**Subject: Dresden Nuclear Power Station Unit 2  
 Systematic Evaluation Program (SEP) Status  
 NRC Docket No. 50-237**

Dresden Nuclear Power Station Unit 2  
SEP Topic III-1

Classification of Structures, Components,  
and Systems (Seismic and Quality)

Figure 1 Two-Dimensional Axisymmetric Finite Element Model Geometry

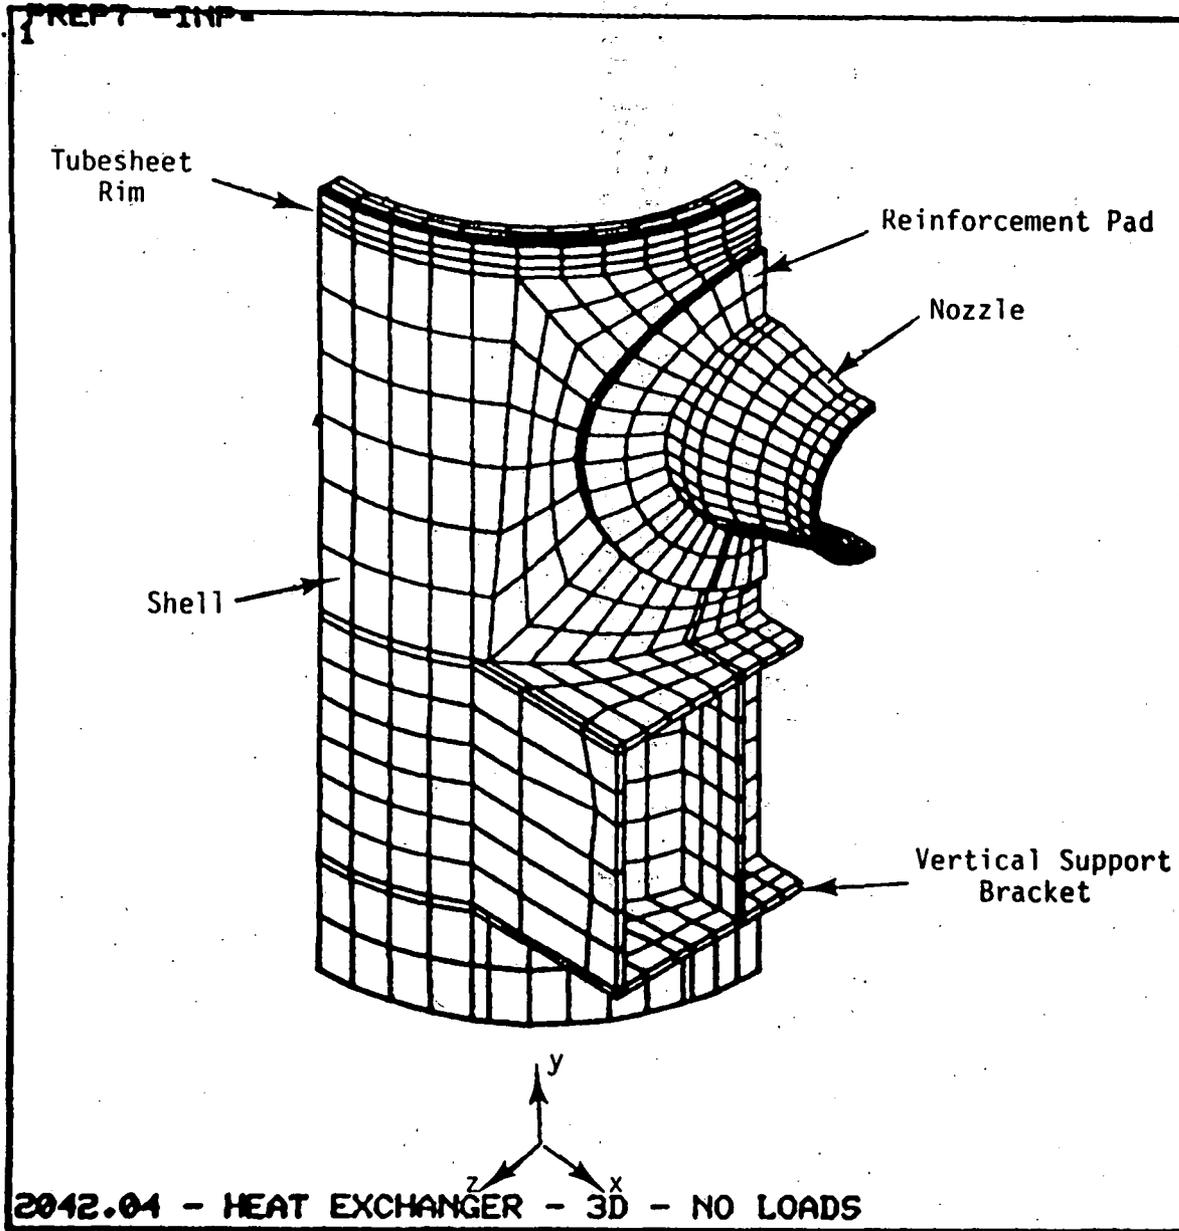
The 2-D model includes the tubesheet, the head, the tubes, the closure studs and one-half of the shell barrel (see Figure 1). Analyses that were performed using this model include the structural (internal tube side and shell side pressures and bolt preload) and thermal load conditions that the HX is subjected to. The 3-D model includes the shell side outlet nozzle, the nozzle reinforcement pad, the vertical support bracket, the tubesheet rim and the shell barrel (see Figure 2). This model represents the most highly stressed region of the HX. Displacements calculated by the 2-D model were applied to the detailed 3-D model at nodes which represent common locations in the two models.

Figure 3 Material Toughness

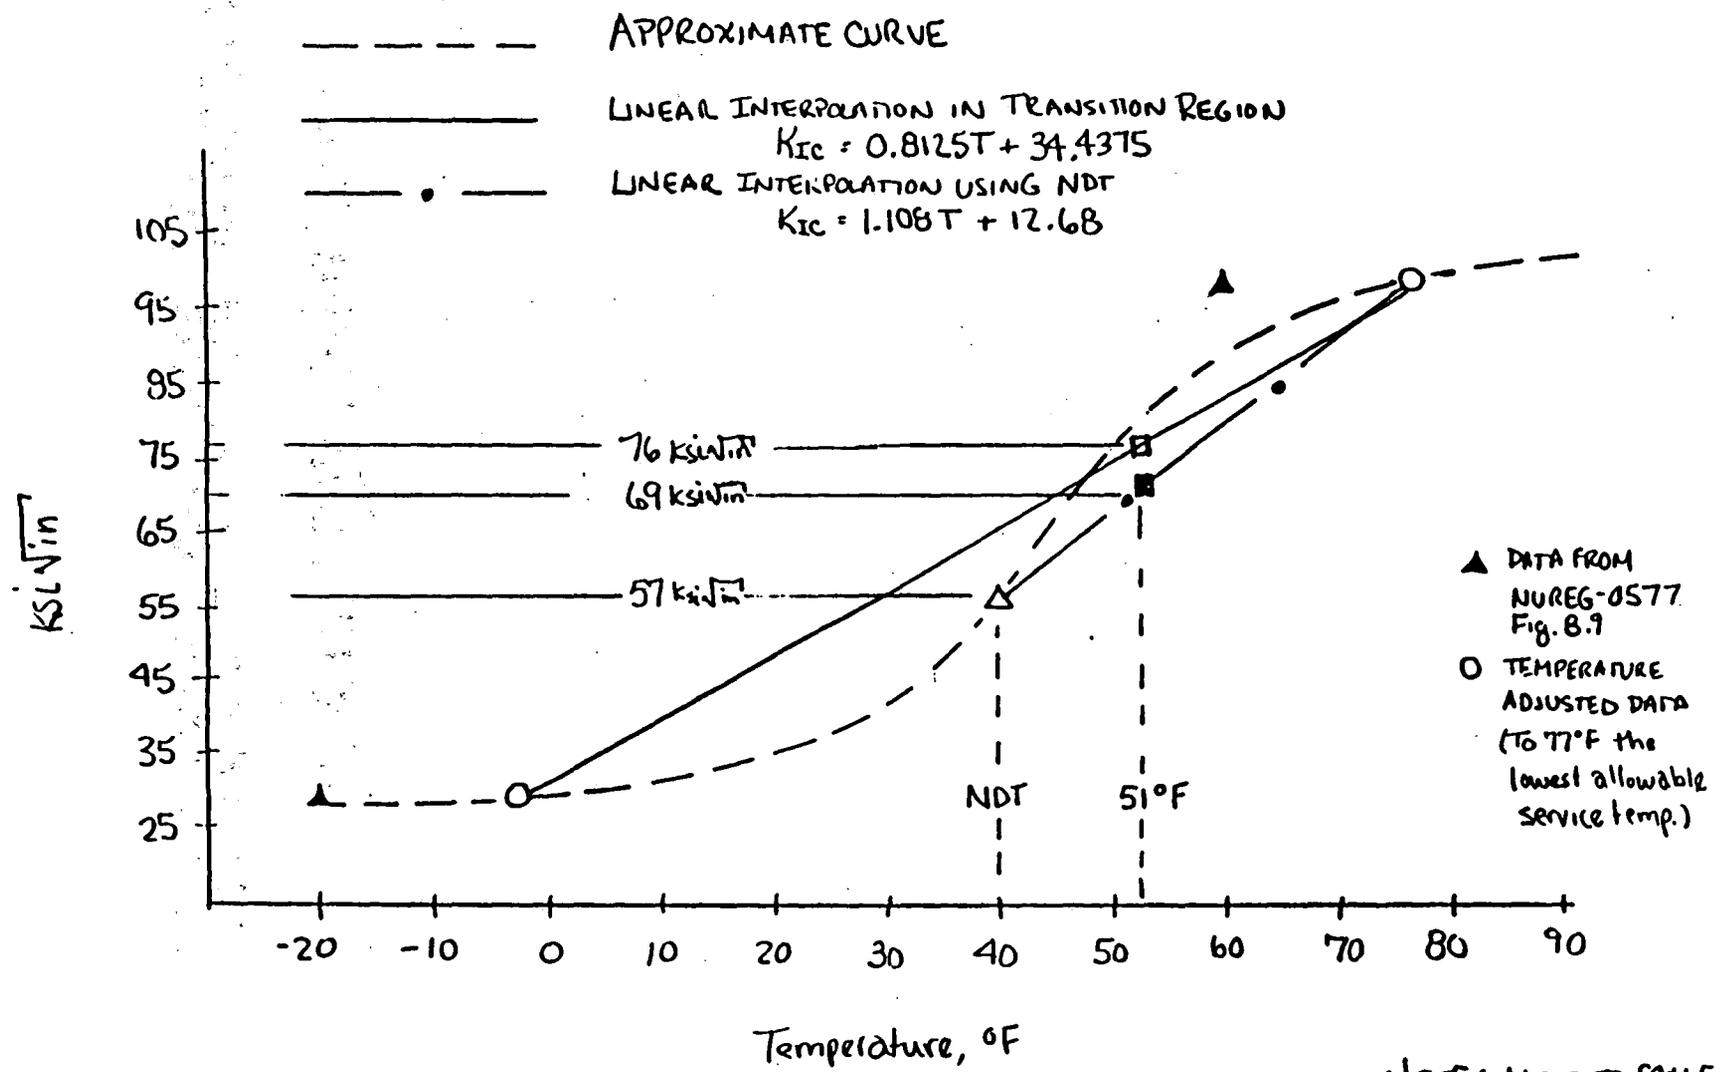
To relate this information to the average nil ductility temperature (NDT) of 40°F,  $K_{IC}$  was calculated per the procedure in Rolfe and Barsom, Fracture and Fatigue Controls in Structures, Sec. 6.4, herein referred to as Reference 1. The straight line between this value, 57 ksi  $\sqrt{\text{in}}$ , and the adjusted upper bound of the transition region, 98 ksi  $\sqrt{\text{in}}$ , could also be used to conservatively evaluate  $K_{IC}$  at 51°F as indicated on Figure 3. It was judged that this  $K_{IC}$  value of 69 ksi  $\sqrt{\text{in}}$  is unnecessarily conservative, so the 76 ksi  $\sqrt{\text{in}}$  was used in the fracture mechanics evaluation. However,

$@NDT \Rightarrow K_{Ic} = \sqrt{EA(CVN)^2}$   
 $E = 28.8 \text{ msi}$   
 $A = 5$   
 $CVN = 22.5 \text{ ft-lb}$

$K_{Ic} = 57 \text{ ksi}\sqrt{\text{in}}$

Figure 4a

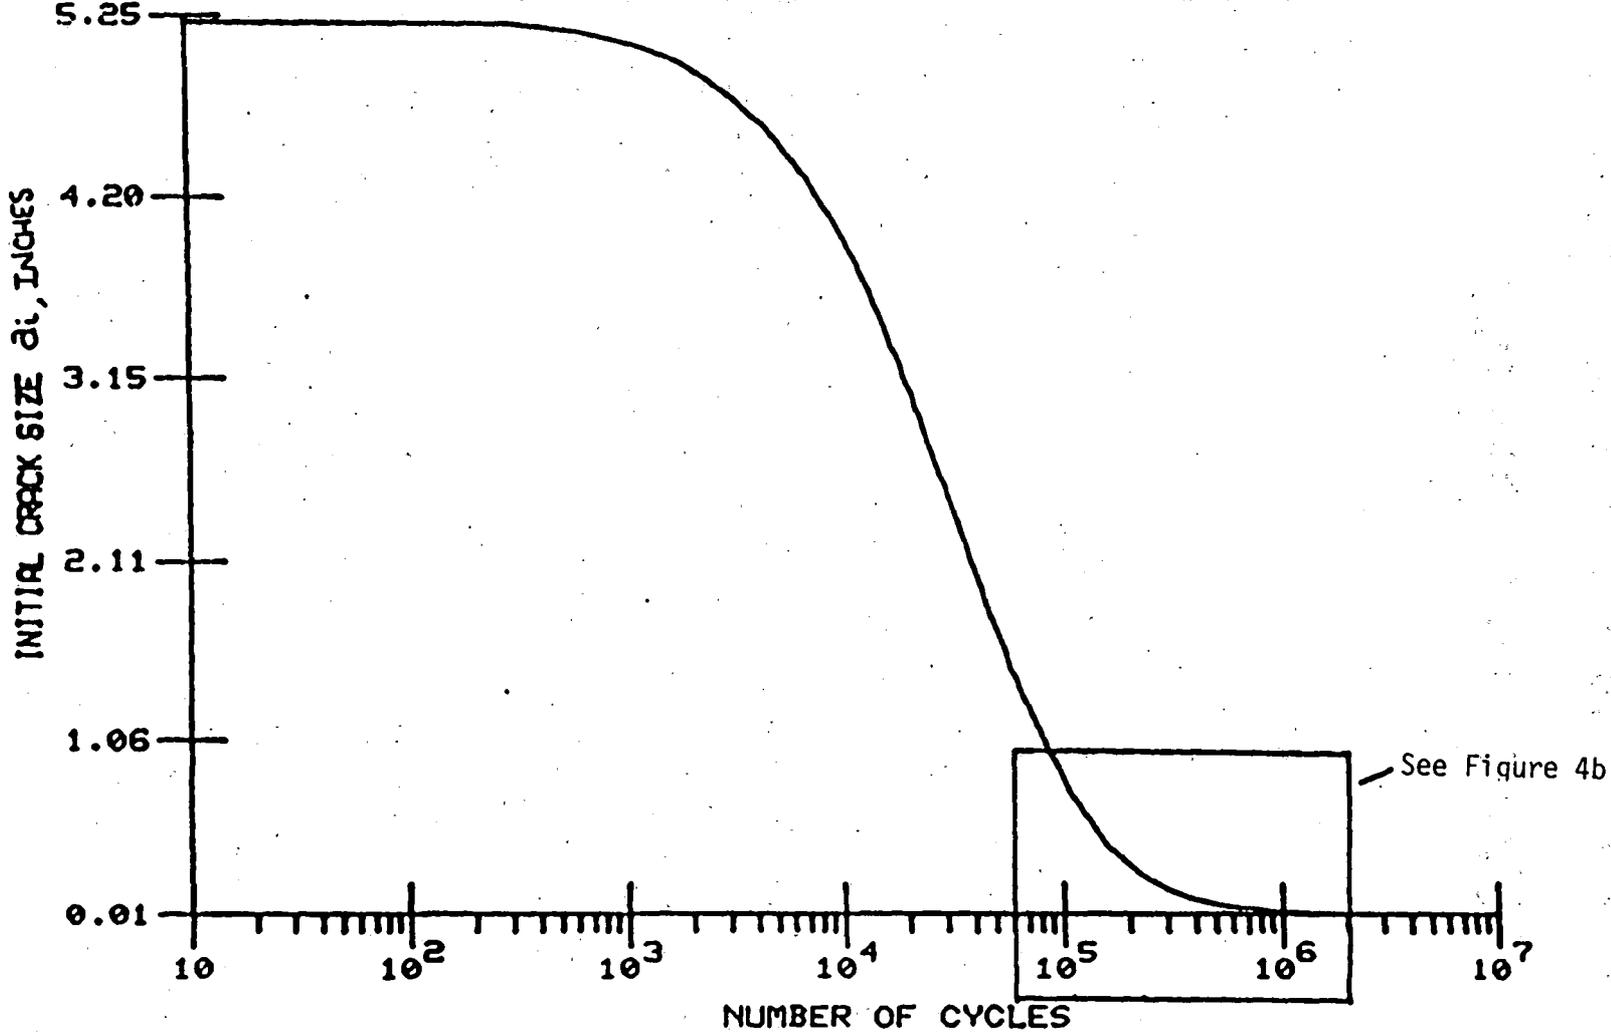
For the calculated maximum principal stress, 16.7 ksi, from the 3-D analysis, the critical crack size is 5.25 inches. Using the maximum stress range and the crack growth rate equation from p.234 of Reference 1, the number of cycles, N, required for various assumed initial crack sizes,  $A_i$ , to grow to the critical crack size,  $A_{cr}$ , is calculated. See Figures 4a and 4b for plots of  $A_i$  vs. N for the LPCI-HX.

It was concluded, based upon an initial crack size of .010 inch (chosen as the maximum crack size that could go undetected by inspection of the unit at the time of its construction) and a cold shutdown temperature of 51°F, that the number of cycles that would be required to propagate a crack of this size to the critical crack size is approximately  $1.5 \times 10^6$ . Based solely from this fracture mechanics analysis and a system startup and shutdown cycle occurring on an average of once a month, the acceptable number of cycles is far beyond any anticipated service life of the LPCI-HX as well as several orders of magnitude beyond the maximum conceivable plant lifetime including life extension. Therefore, the fracture toughness of the shell side of the LPCI-HX would be more than adequate.
